| ROADWAY PLAN                                                         |                                                    |
| INTERSTATE ROUTE H-1 RESURFACING                                     |                                                    |
| Miller Pedestrian Overpass to Kapiolani Interchange                  |                                                    |
| Federal-Aid Project No. NH-HI-1(279)                                 |                                                    |

| SHEET No. R17 OF 41 SHEETS                                                                                                      |                    |

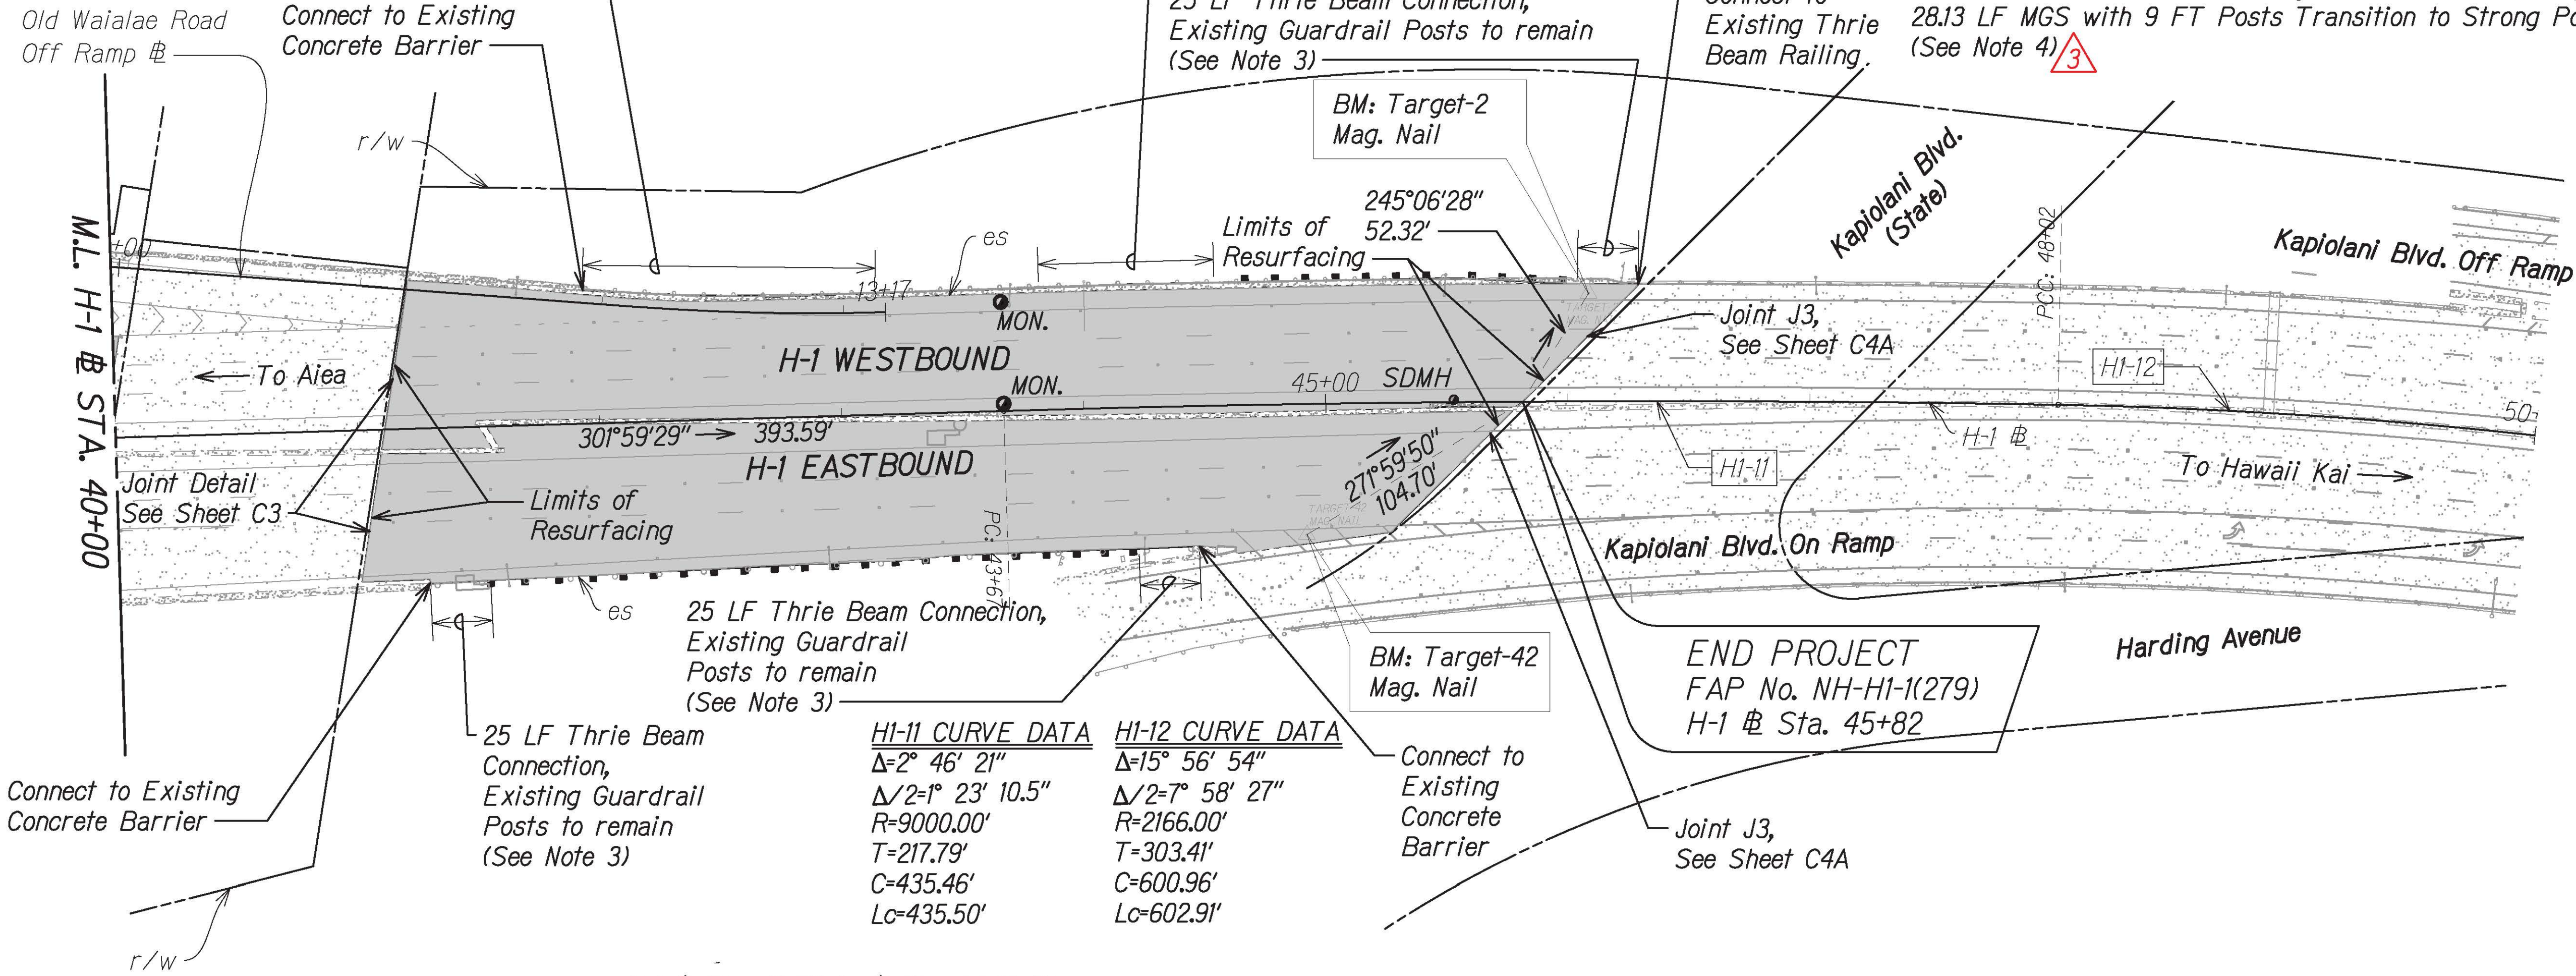
| 7/9/21                                                                                                                          | Revised Guardrails |

| SHEET No. R18 OF 41 SHEETS                                                                                                      |                                                              |

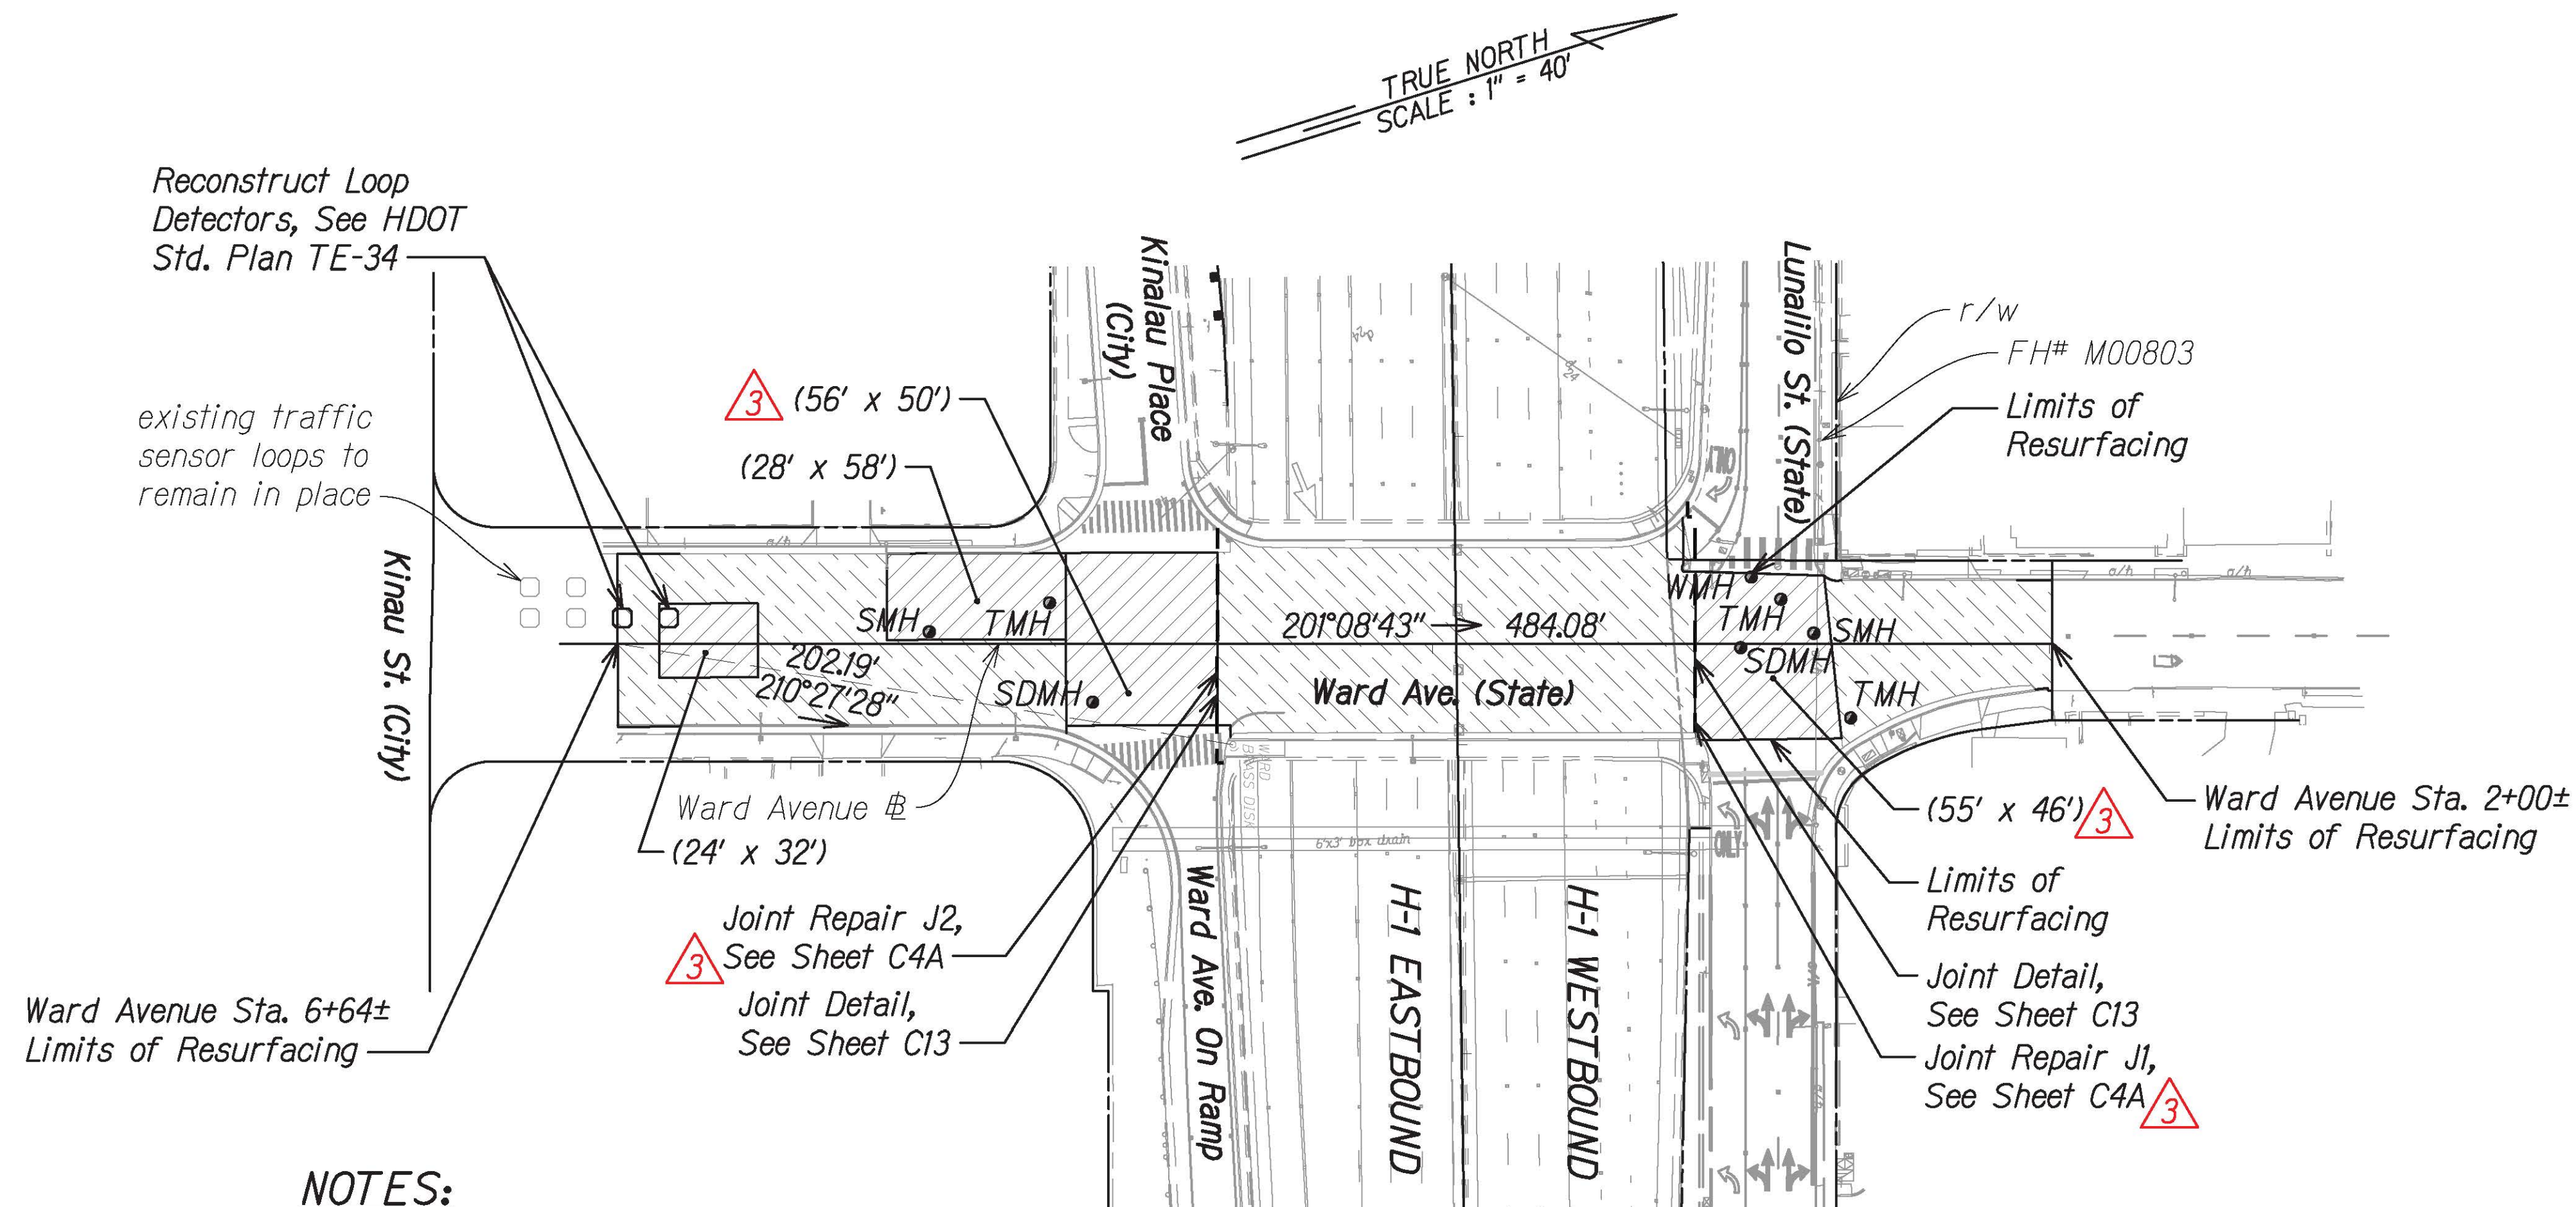
| 7/9/21                                                                                                                          | BWS Tracings, Added Joint Repair, Revised Resurfacing Limits |

| SHEET No. R20 OF 41 SHEETS                                           |                                      |

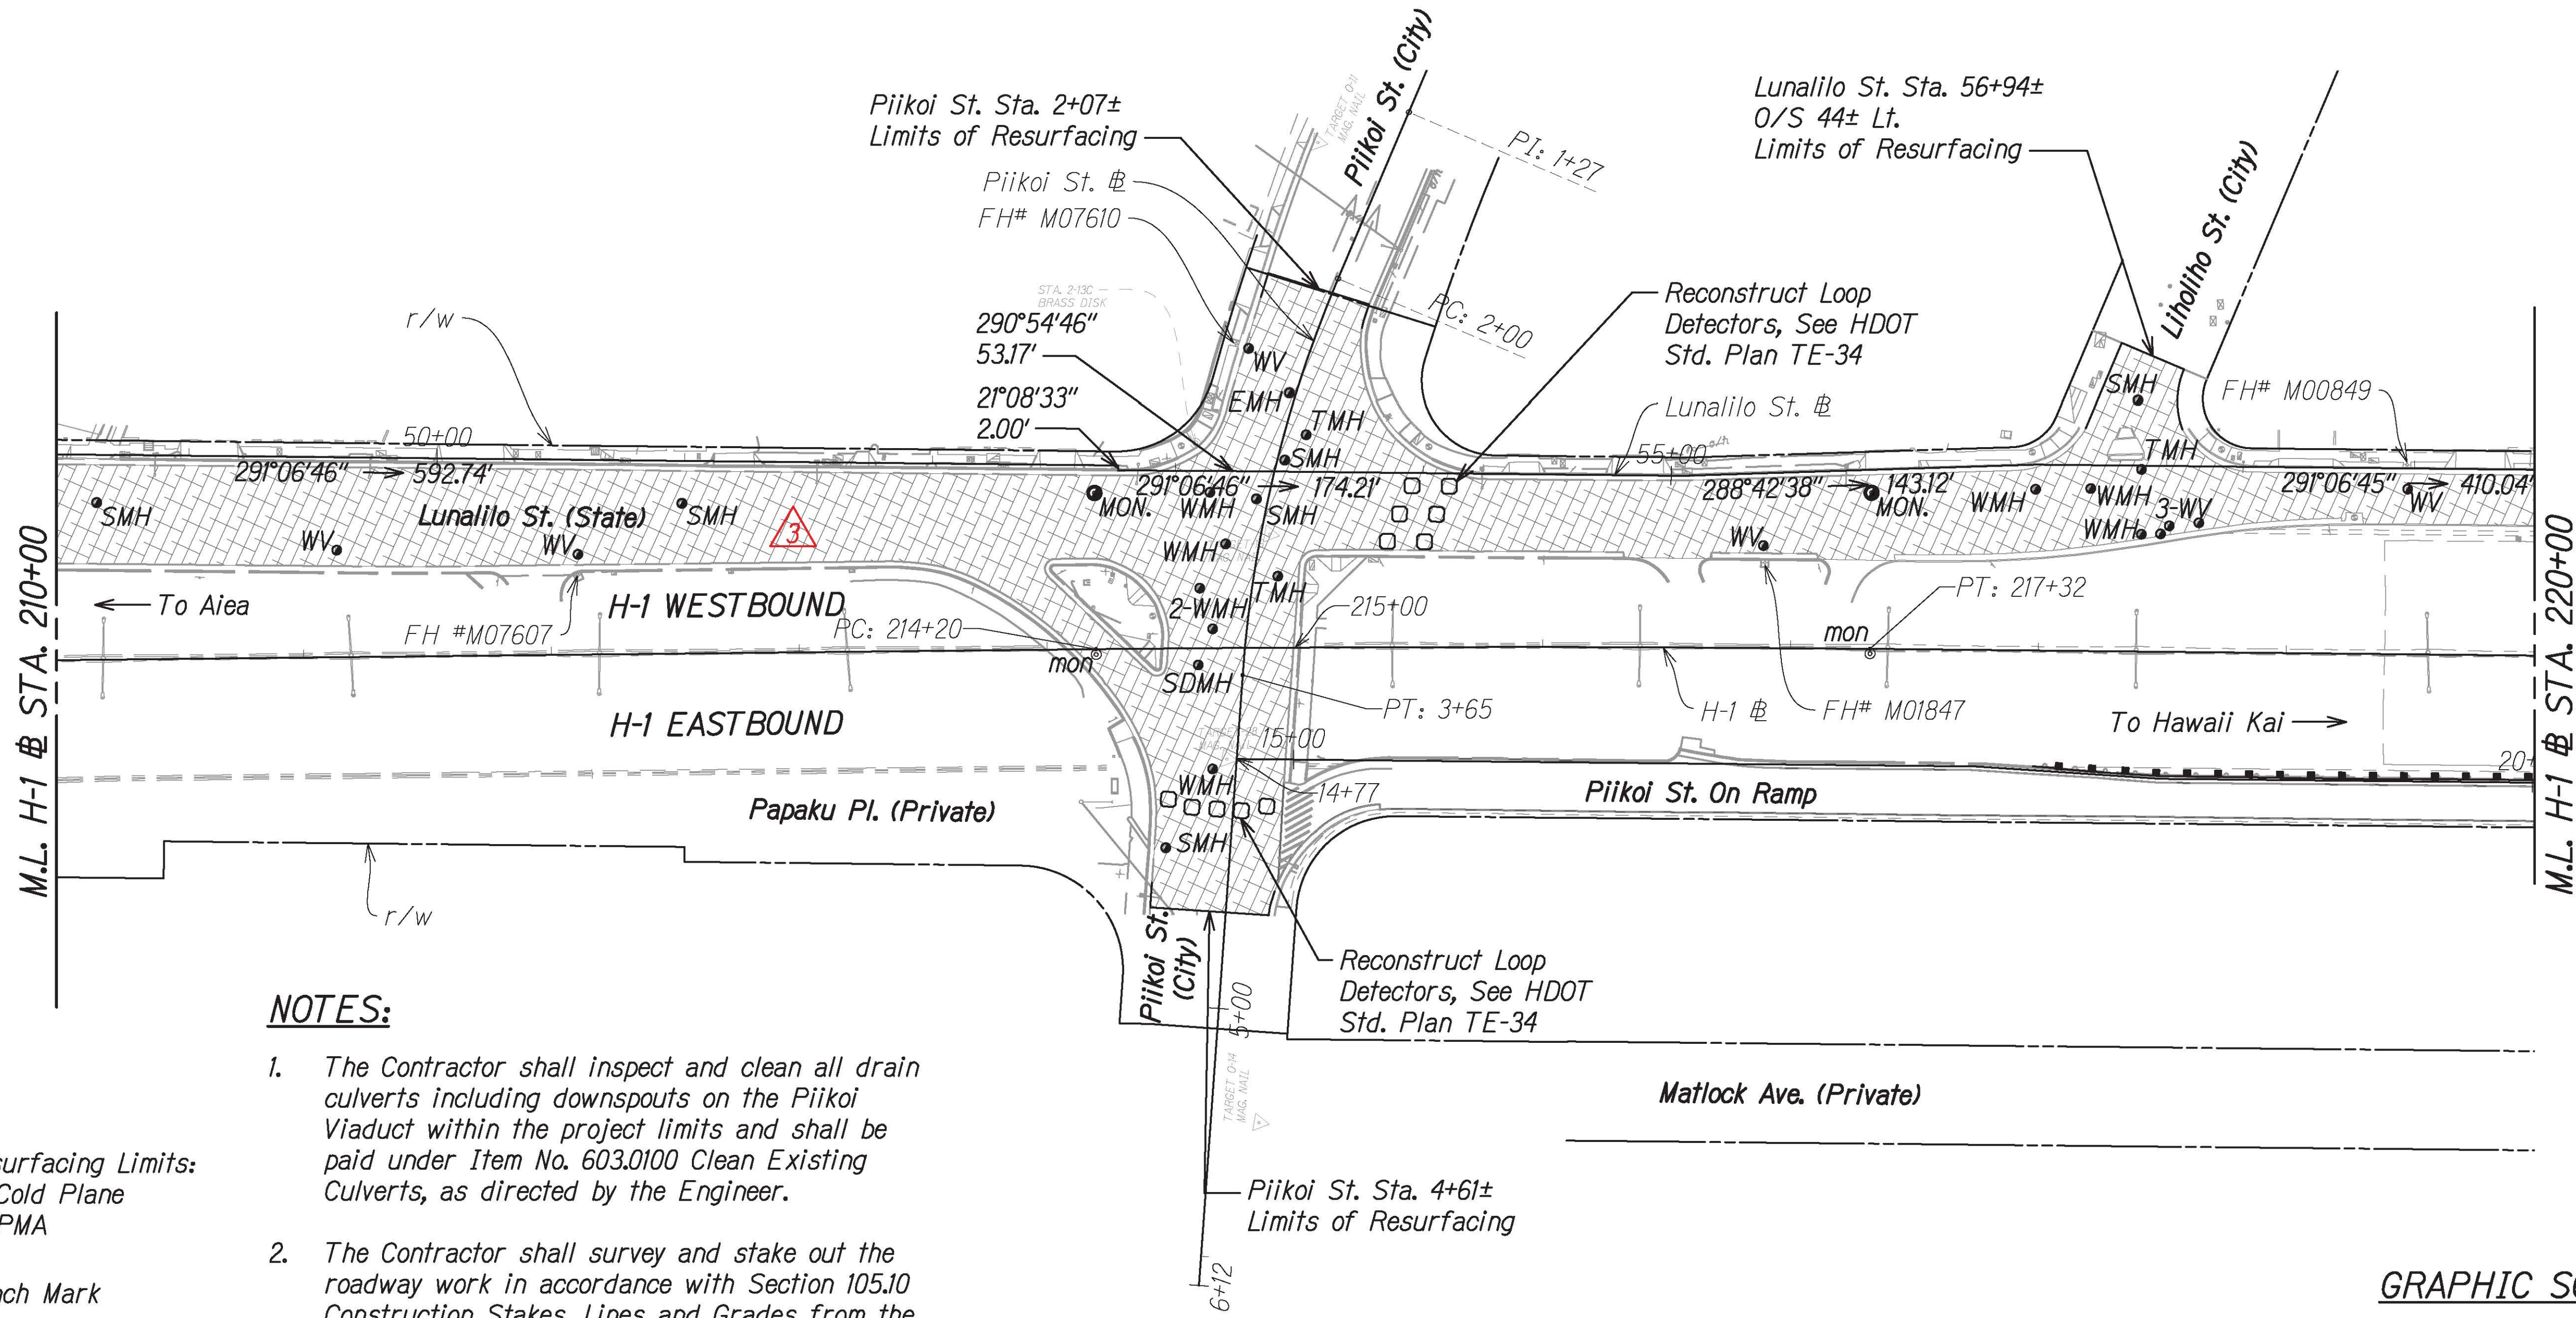
| 7/9/21                                                               | BWS Tracings,<br>Revised Resurfacing |
